EirGrid and ESB Networks' proposal for
the general application of technical
requirements in accordance with Articles
13 – 28 of the Commission Regulation
(EU) 2016/631 establishing a network code
on requirements for grid connection of
generators

16 May 2018

Figure 1 Maximum Power Capability Reduction with Falling Frequency

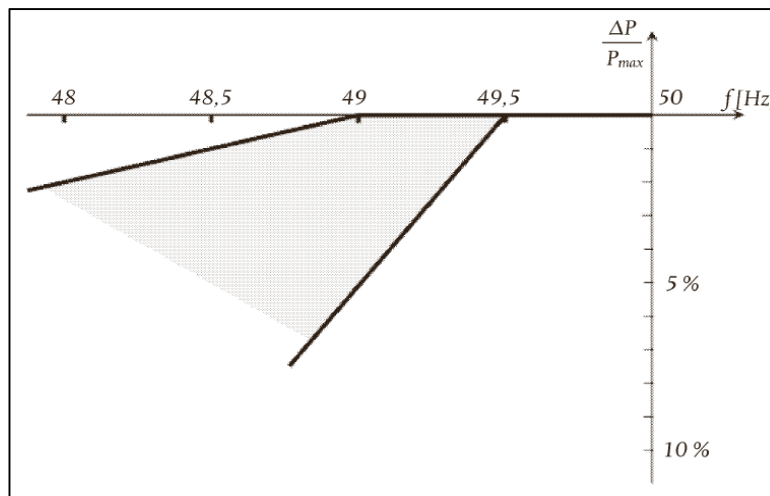
One respondent commented that a gas turbine technology output at falling frequency neither is non-linear nor can be controlled since intrinsic to the generating unit itself. The 49 Hz, 2% power drop at the specified ambient conditions is not a realistic characteristic for any gas turbine, regardless of whether the technology is single or multi shaft. They commented that EUTurbines have been presenting examples and explanations including the characteristics, of GT technology since 2012. The proposals presented here exceed the presentations from EUTurbines. They also comment that every gas turbine has its own characteristics. They suggest that a possible approach is to leave the characteristic as defined in the proposals and to request GT manufacturer to provide expected power deviation function of ambient temperature.

One respondent commented that Art 13.5 is used for GT unit to complement art 13.4, by providing ambient condition and taking into consideration the technical capabilities of the correspondent technology. They comment that this Article was created to accommodate gas turbine technologies; however the way it was defined is poorly reaching the goal, since every GT performs differently. It is suggested that a possible approach is to leave the characteristic you defined as reference for all and to request GT manufacturer to provide expected power deviation function of ambient temperature. This would fulfill also the 13.5. They noted that; the requirements are only critical at full power for GT characteristic and that the requirement cannot be tested and it doesn't drive competition.

Furthermore, post consultation and following further clarification from ENTSO-E in the form of the IDG “Maximum Admissible active power reduction at low frequencies” dated 31/01/2018, the initial proposal has been revised to the following:

As per the ENTSO-E IGD "Maximum Admissible active power reduction at low frequencies" dated 31/01/2018, the PGM should provide the characteristic expected over a full temperature range (eg-10oC - 40oC). The performance specified under Article 13.5 is at 10°C.

Figure 4: PPM U-Q Profile @ Pmax connected at a voltage level <110 kV

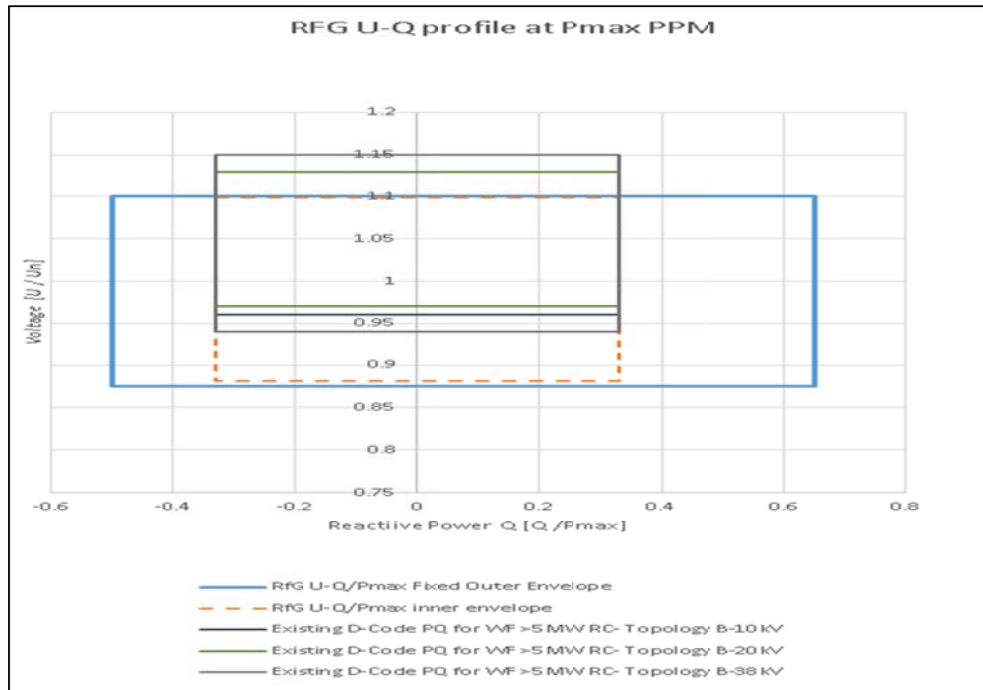
Clearly these are currently outside the allowable limits specified in RfG. See Section 3.3 above for the proposed methodology for resolving this issue.

Figure 7: FRT capability for SPGMS connected @ <110 kV

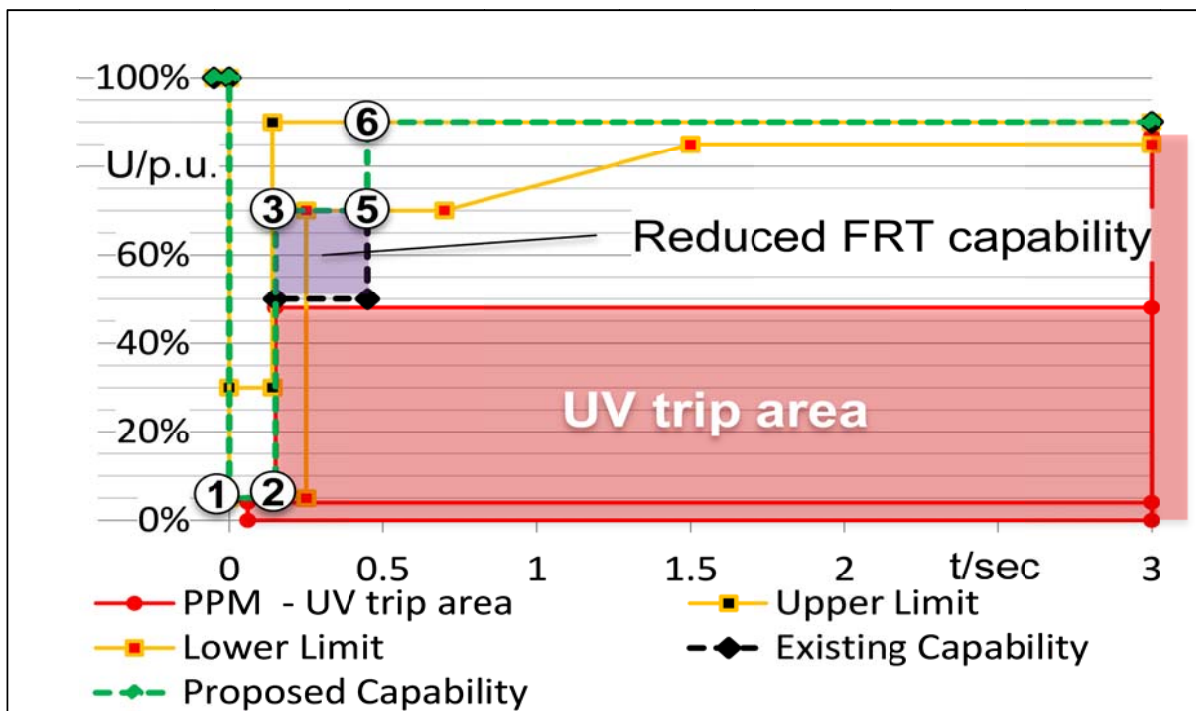
A change is needed here to comply with RfG. The points (150ms, 0.5 p.u.) and (450 ms, 0.5 p.u.) have to move to (150 ms, 0.7 p.u.) and (450 ms, 0.9 p.u.), respectively in order to come within the stipulated envelope.

Figure 8: FRT capability PPM connected @ <110 kV

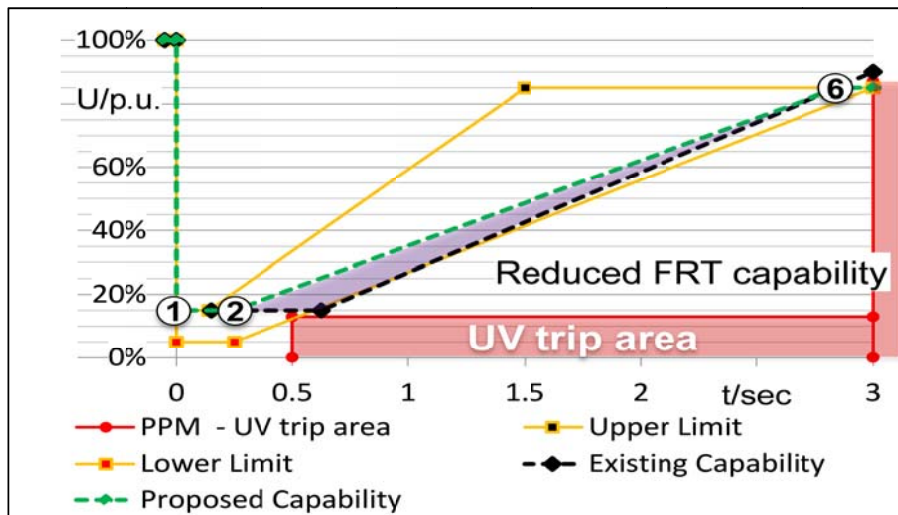
Fault ride through capability changes slightly. Point (2) to (5) at (625 ms, 0.15 p.u.) moved to (250 ms, 0.15 p.u.). This will give a greater margin between this point and the under-voltage setting of 0.13 p.u. for 0.5s. Figure 8 shows the fault ride through capabilities including for completeness, the under-voltage protection settings (UV trip area) and RfG boundaries.

Figure 10: FRT capability of PPMs connected at ≤ 110 kV

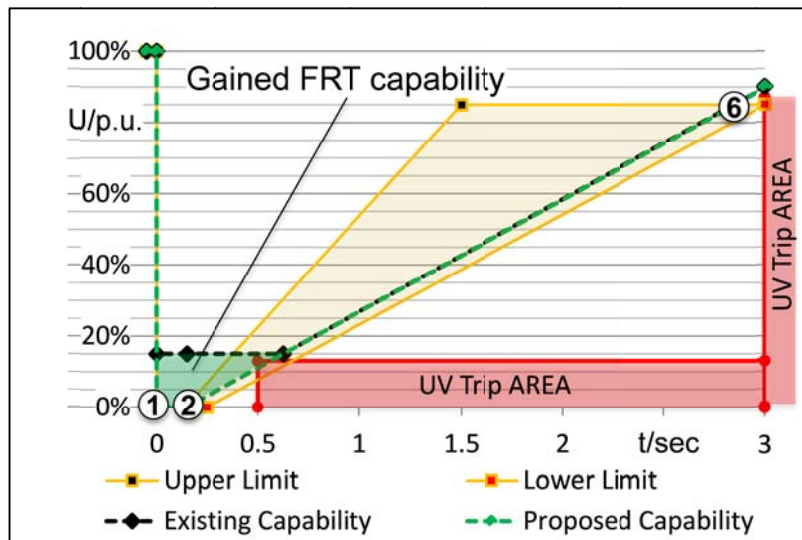
It is noted that these proposed FRT capability requirements, conflict with the current protection settings for under voltage relays. However in the future, these protection settings may change and the FRT capability needs to remain.

Technical and ambiental limitations to be considered in requirement !

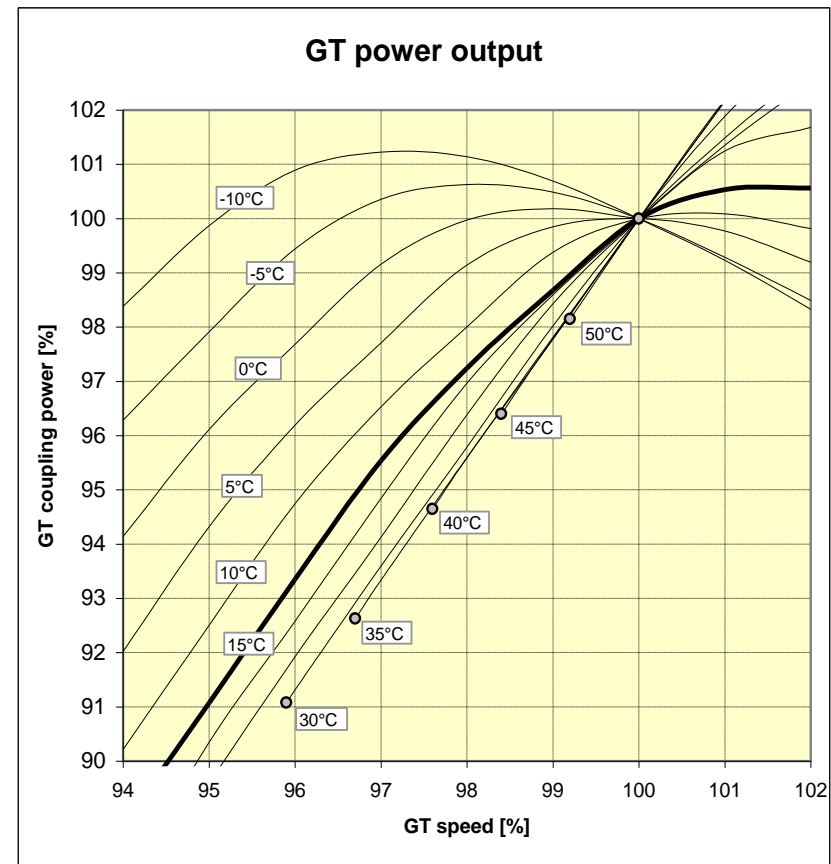
- Gas Turbines output is influenced by different external factors. Depending on ambient conditions, power drop exceeds allowed values in Art 13 figure 2.
- Principle steady-state behaviour is shown in att. figure (values are only indicative!)
- Dynamic behaviour is worse since compensating power control loops need time to react to frequency drop (if reserve is available)

Power vs. frequency: Recommendations

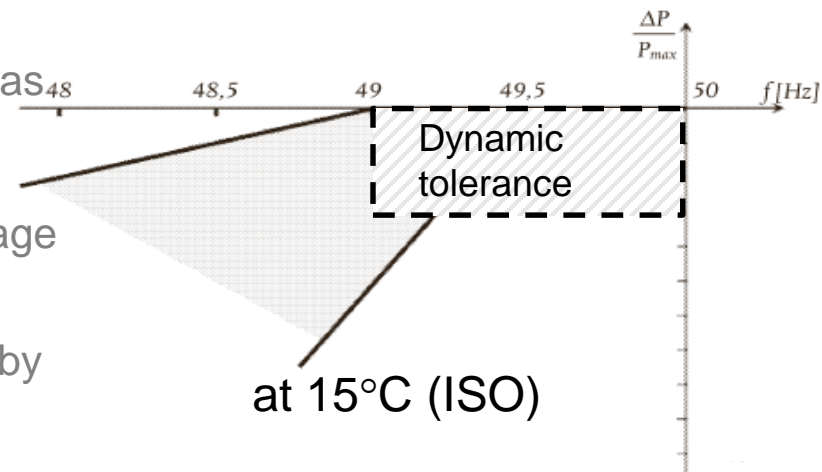
- Apply lower end of RfG range in Art 13 fig 2 for steady-state
- Allow further relaxation according to Art. 13 (5) (a) in case of evident technical constraints (without derogation process); consideration of known behaviour of plants at maximum output is better for system stability than increased risk of trip!
- Allow further relaxation in case short-term dynamic requirement (timeframe tbd) is deemed to be necessary and allowed by RfG
- Apply ISO 2314 reference temperature (15°C) as the relevant ambient condition to both steady-state and dynamic requirement (if applicable): standard condition for turbine design and average temperature in many countries in the EU
- Behaviour at other conditions can be provided by manufacturers on a project specific basis for consideration in system studies
